SUBJECT: ADMINISTRATION AND EARLY LEARNING CENTER ADDITIONS
ORCHARD FARM R-V SCHOOL DISTRICT
ST. CHARLES, MISSOURI
PROJECT # 23-09C

ORCHARD FARM R-V SCHOOL DISTRICT
ADMINISTRATION AND OFFICE ADDITIONS
ST. CHARLES, MISSOURI

AUGUST 1, 2024

The drawings and specifications are hereby supplemented and amended to include the following particulars:

PARTIAL SYSTEMS NEW WORK PLAN
SCALE: 1/8" = 1'-0"

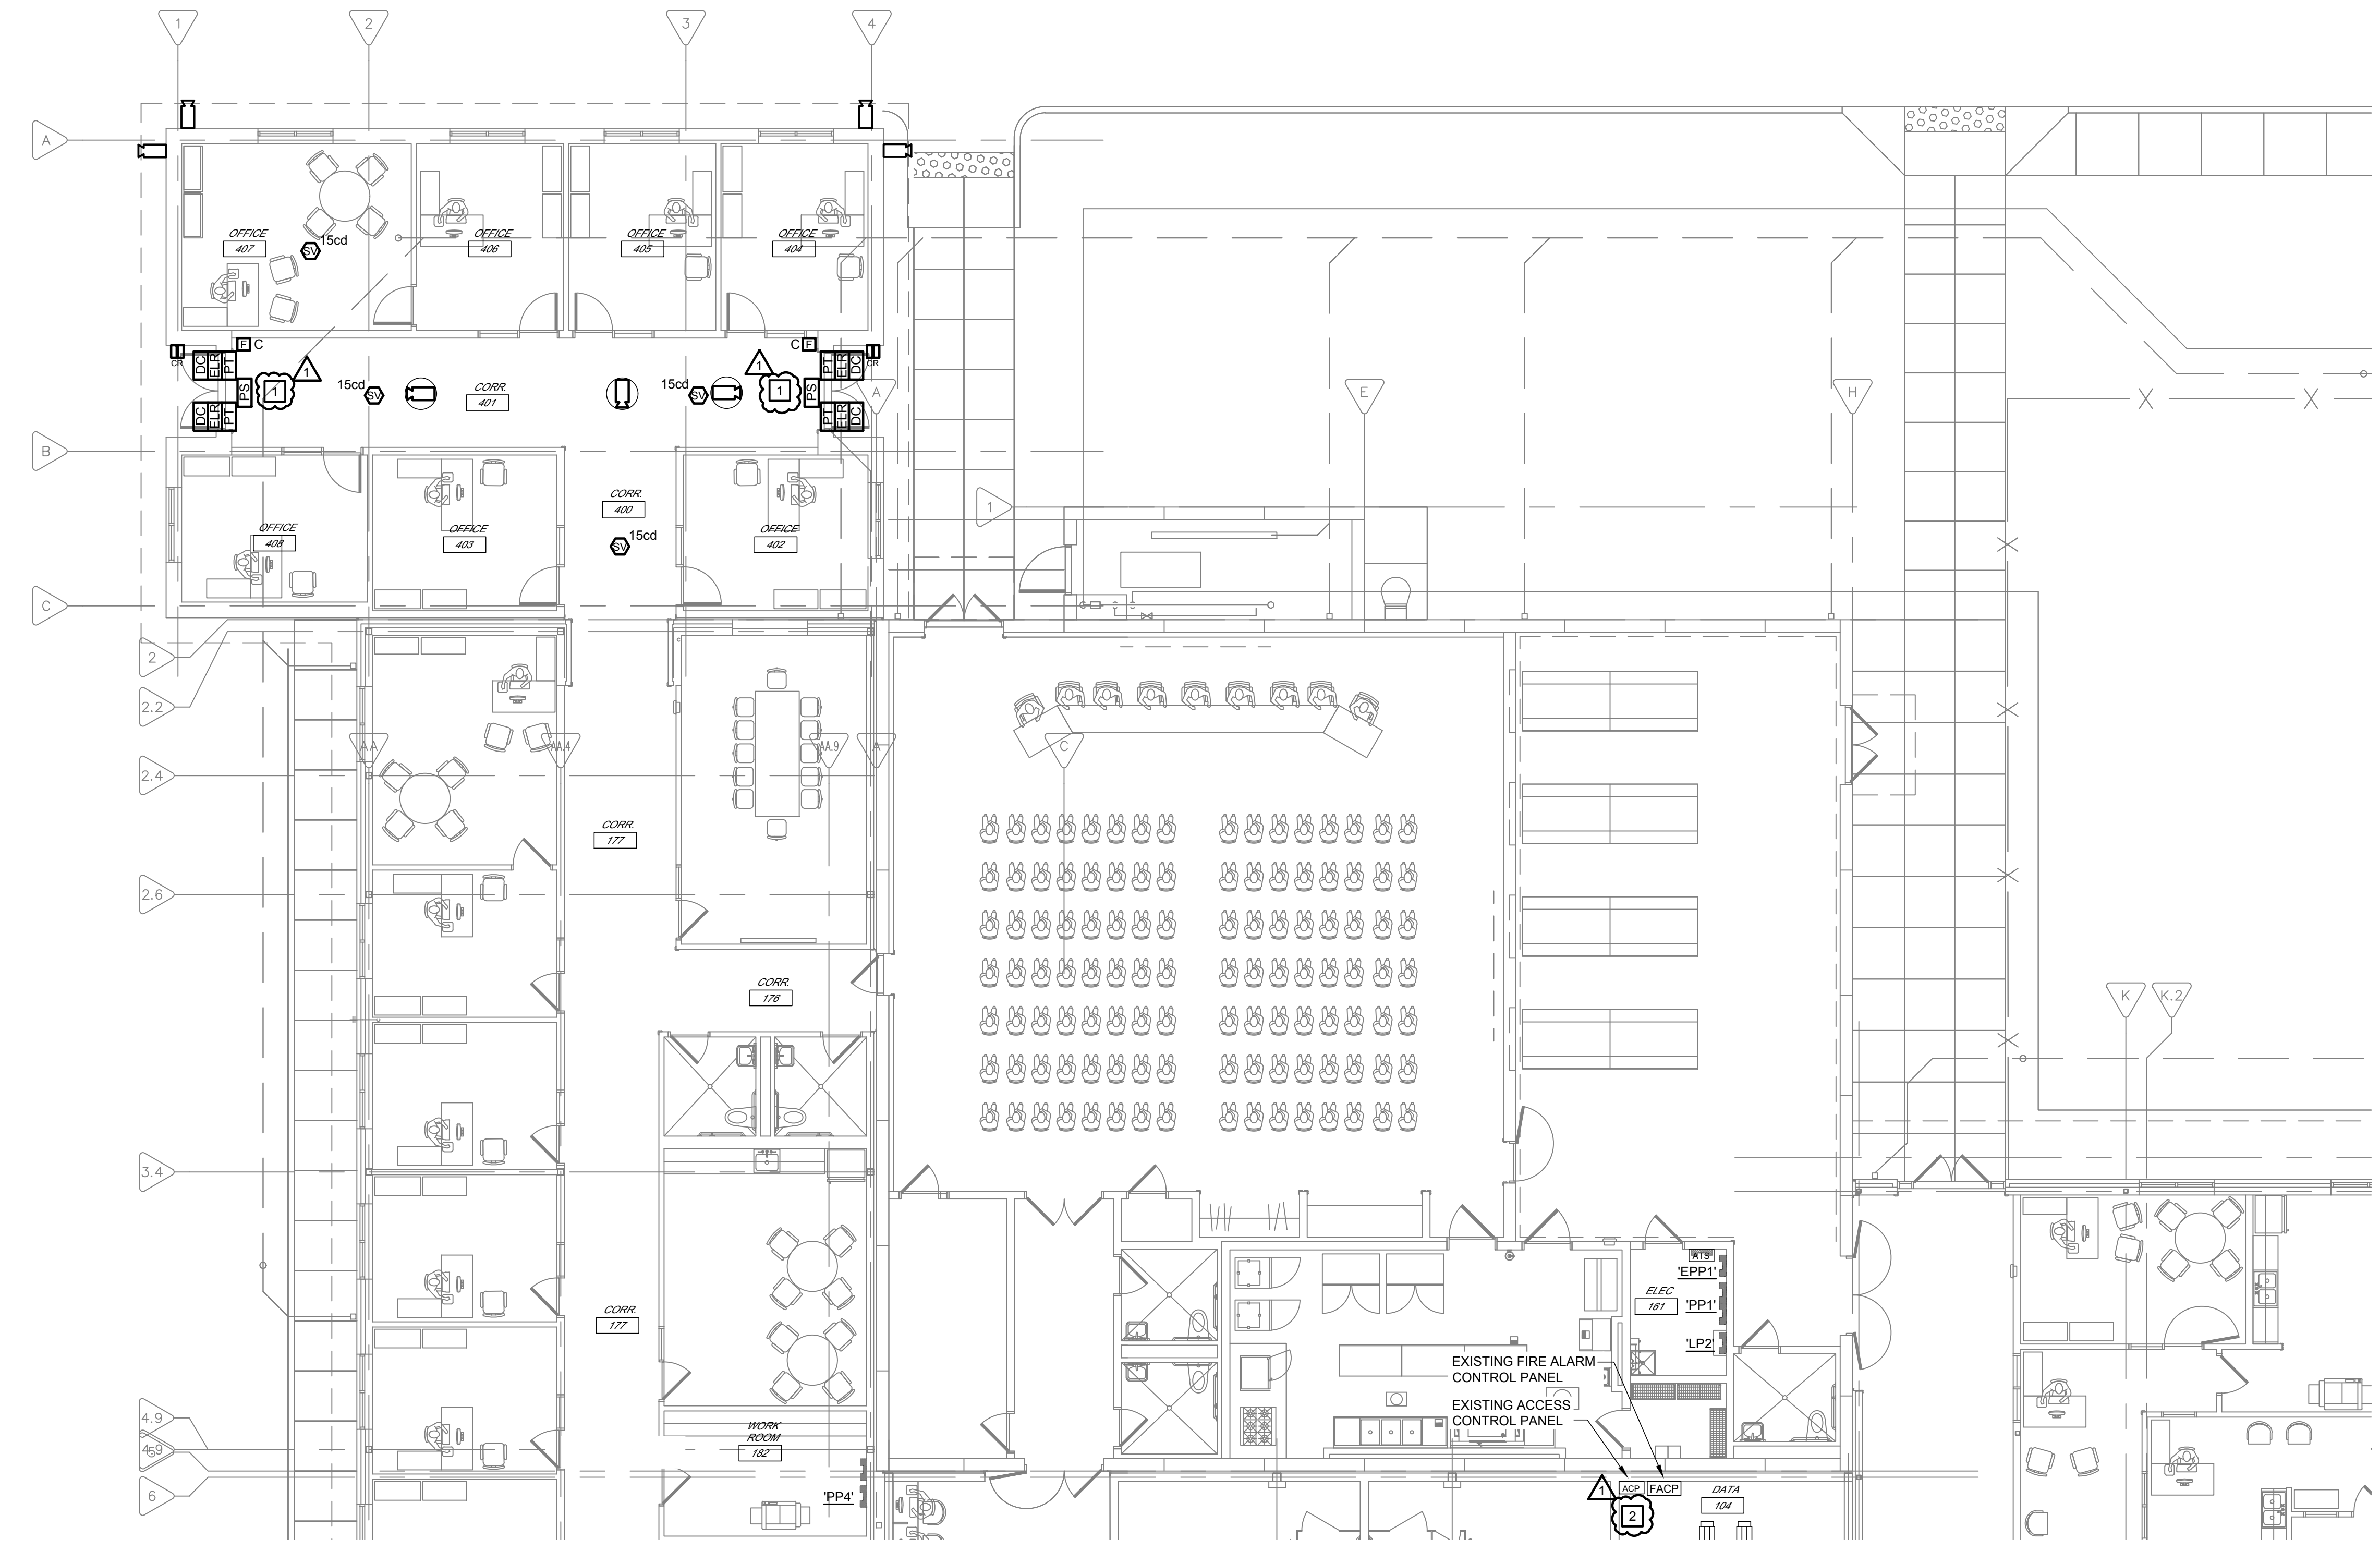
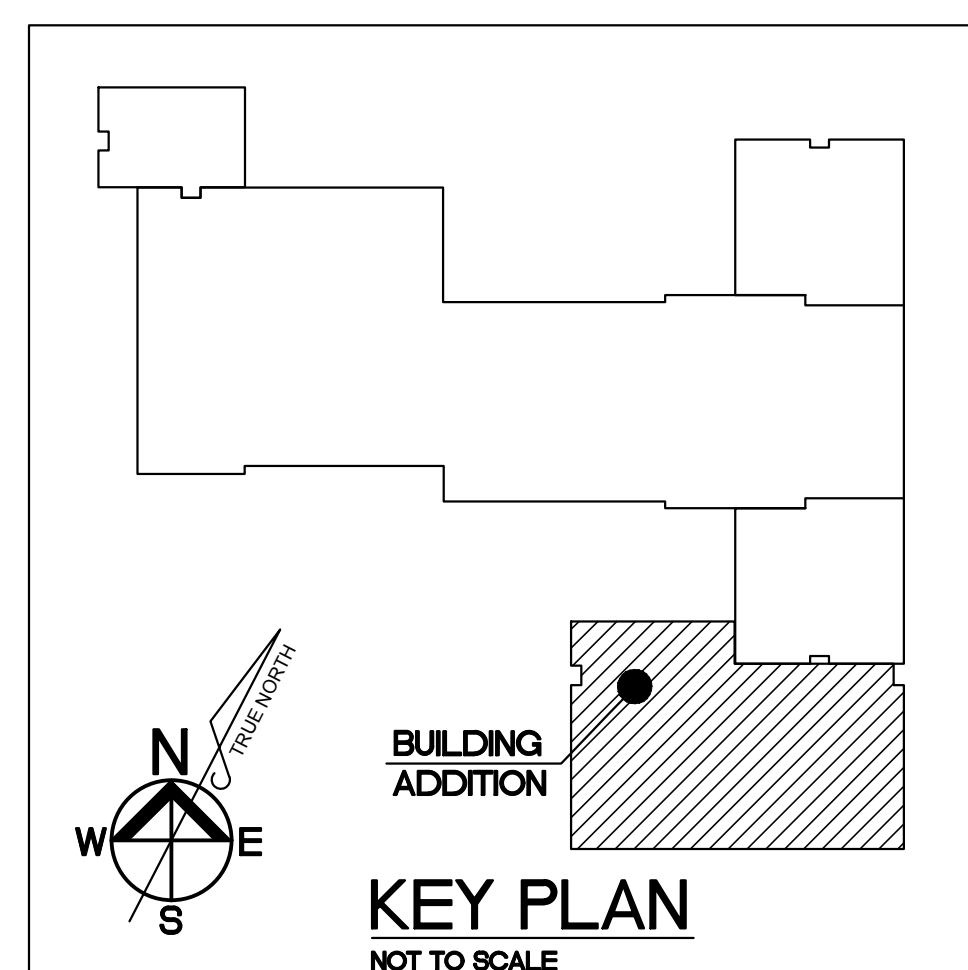
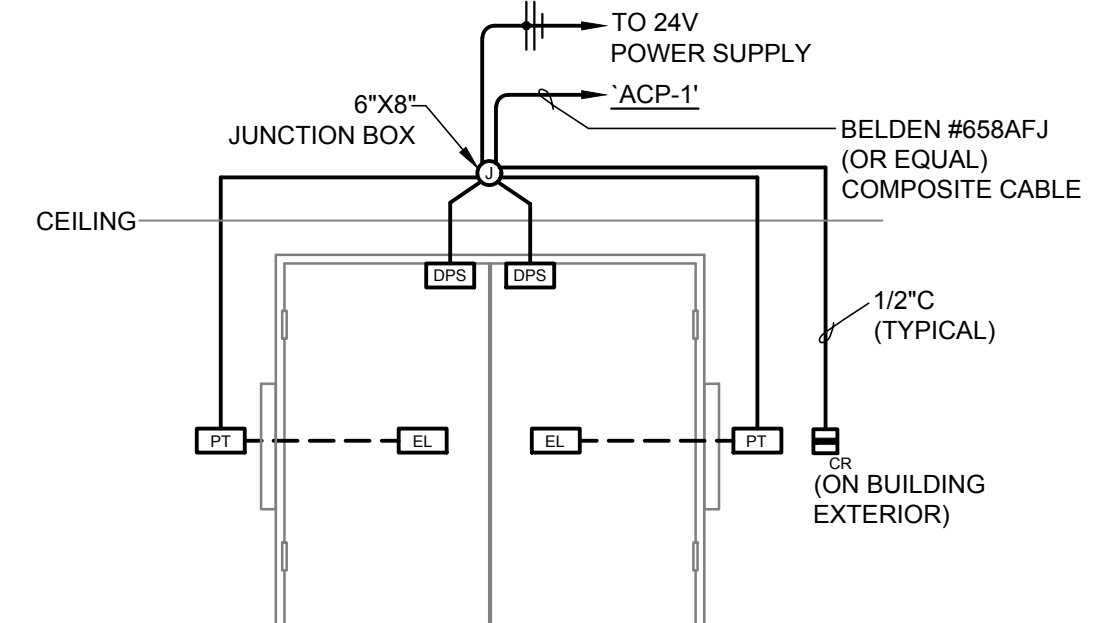
- A. “ADD” GENERAL NOTES
 1. Added general note #10 to clarify crossover between existing and new scope.
- B. “ADD” KEYED NOTES
 1. Added keyed note #1 to clarify the owner-preferred installation method of new door access controls.

PARTIAL SYSTEMS NEW WORK PLAN - ALTERNATE #1
 SCALE: 1/8" = 1'-0"

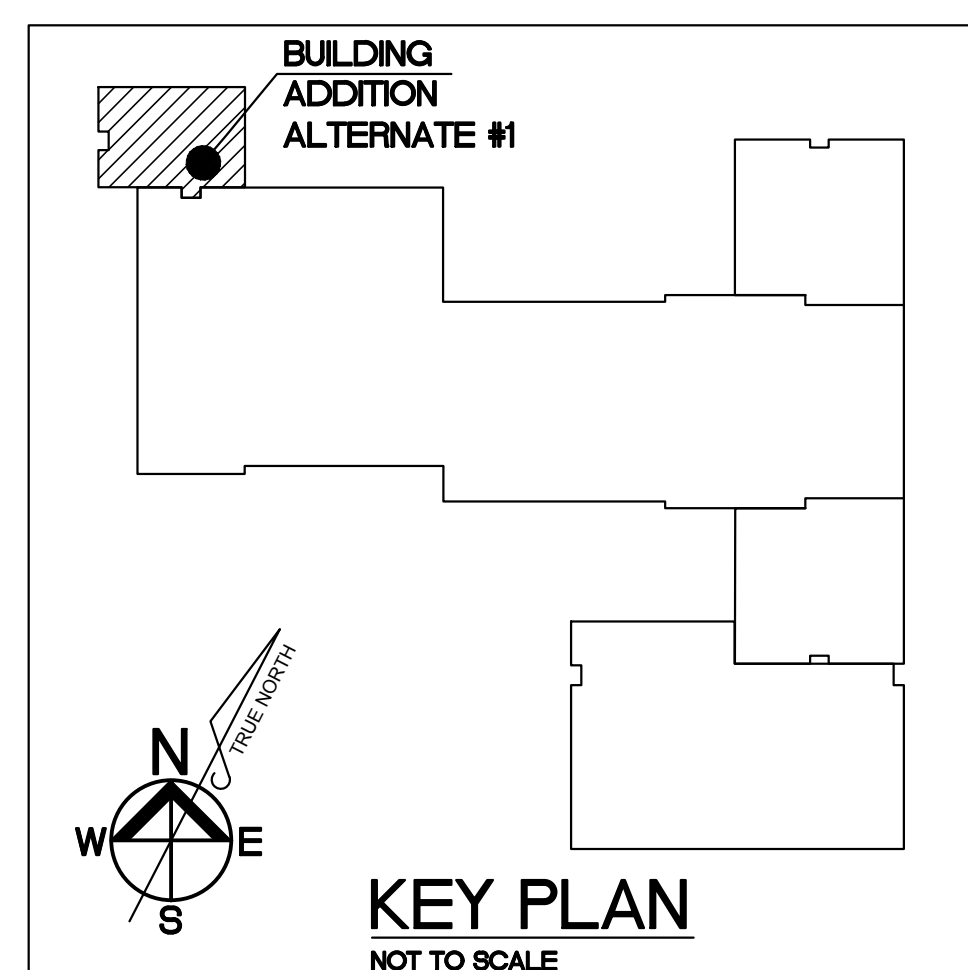
- A. “ADD” GENERAL NOTES
 1. Added general note #10 to clarify crossover between existing and new scope.

B. **“ADD”** KEYED NOTES

1. Added keyed note #1 to clarify the owner-preferred installation method of new door access controls.
2. Added keyed note #2 to clarify possible need for a CPU upgrade within the head-end equipment. This shall be coordinated with the owner and Tech Electronics prior to work being completed.
